TREK ADDITION JSP23-32

Consideration of Special Land Use, Preliminary Site Plan, and Stormwater Management Plan approval at the request of Trek, Inc. for an addition to the existing Trek building. The subject property is composed of two parcels planned to be combined. The first parcel, which contains the existing Trek building, is 0.46 acres in size. The second parcel, which is currently vacant, is 1.56 acres in size. The subject property is located within the Beck North Corporate Park site condo on the north side of Desoto Court, east of Hudson Drive. Both parcels are zoned I-1 Light Industrial. The applicant is proposing to add a warehouse to the existing Trek building to store more material and products for the business.

PLAN REVIEW CENTER REPORT

Review Date: November 30, 2023
Review Type: Preliminary Site Plan Review
Project Name: JSP 23-32 Trek Addition
 50-22-04-378-009; North of Desoto Court, East of Hudson Dr
Plan Date: November 13, 2023
Prepared by: James Hill, Planner
E-mail: jhill@cityofnovi.org **Phone:** (248) 347-0547

Hours of operation are noted on the plans. 8am to 5 pm Mon-Fri.

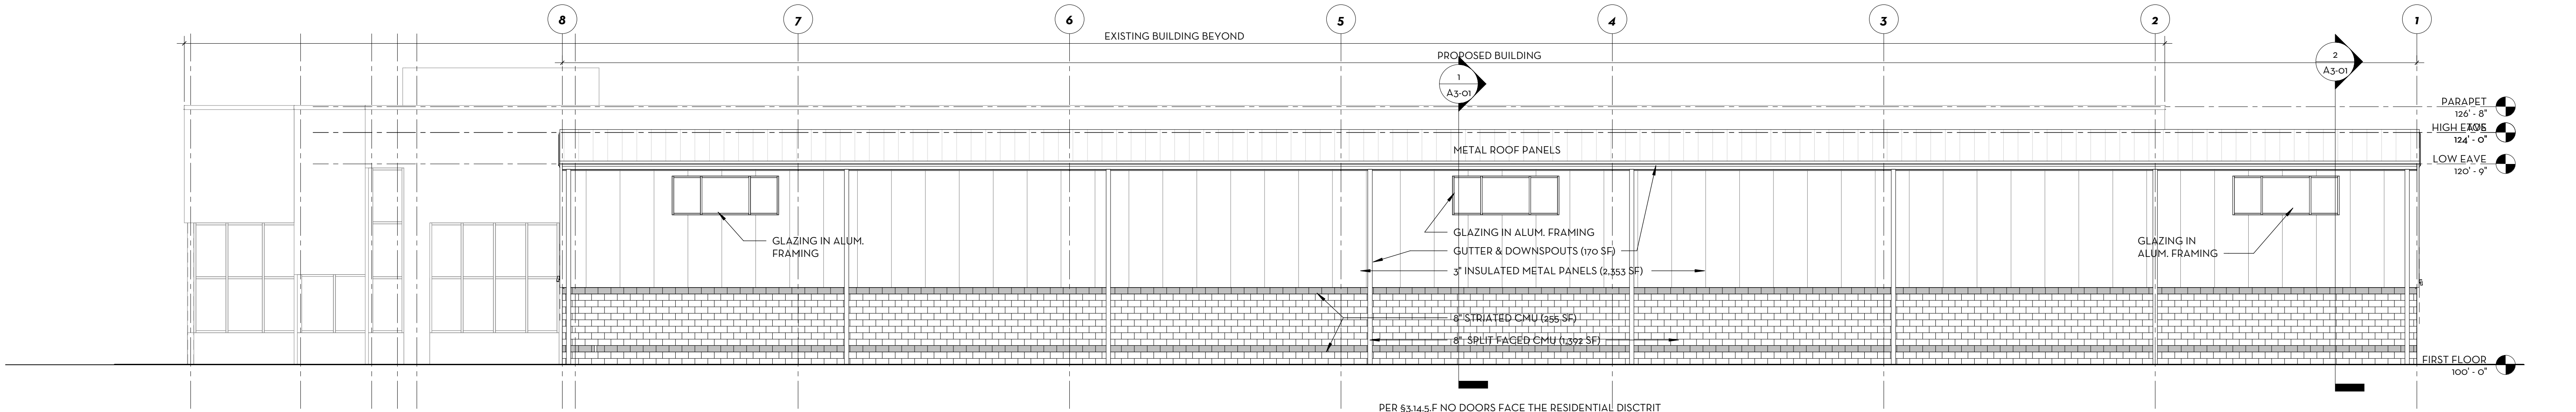
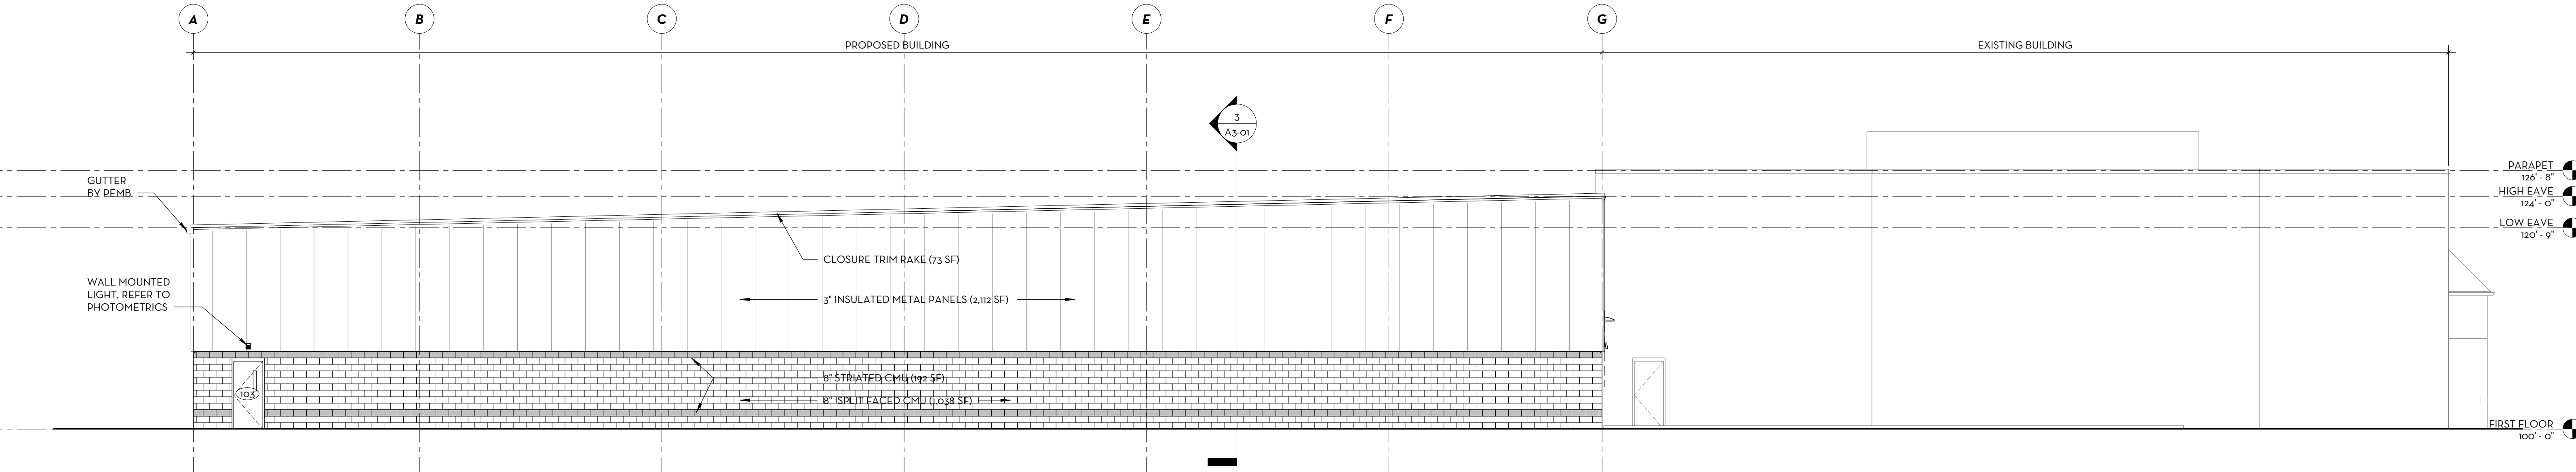
Building Lighting (Sec. 5.7.2.A.iii)	Relevant building elevation drawings showing all fixtures, the portions of the walls to be	Elevation drawings do not show all	No	Please show lighting fixtures on elevation drawings
